APPLICATION NO.	FILING DATE	FIRST NAMED INVENTOR	ATTORNEY DOCKET NO.	CONFIRMATION NO.
10/709,172	04/19/2004	Brian Arnott	060494-0001	1757

Office Action Summary

ARNOTT, BRIAN

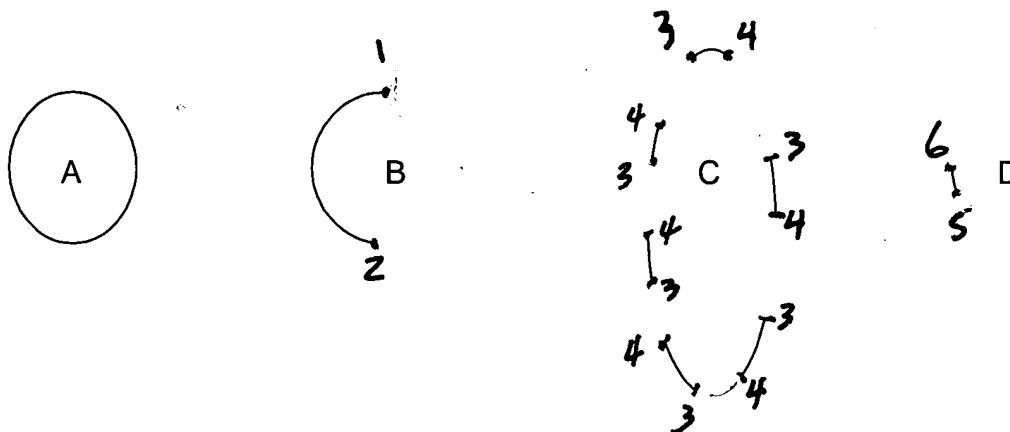
Claims 31 – 35 are rejected under 35 USC Sec. 112(2) for failure to particularly point out and distinctly claim the invention. Claims 31 recites "surrounding the oil container at least in part." It is unclear what it means to "surround" something "in part." For example, while it is clear that in the diagram below that "A" is surrounded by the circle, it is unclear whether "B", "C" or "D" are surrounded at least in part by their respective corresponding arcs 1-2, 3-4, and 5-6.

In short, the concept of surrounding in part is not per se impermissible under 35 USC Sec. 112(2). But the term "surrounded . . . in part" in claim 31 is a relative term which renders the claim indefinite. The term is not defined by the claim, the specification does not provide a standard for ascertaining the requisite degree, and one of ordinary skill in the art would not be reasonably apprised of the scope of the invention. There does not even appear to be a recognition in the art that "surrounded at least in part" means "extending through at least 50% of a circumference of," or the like.
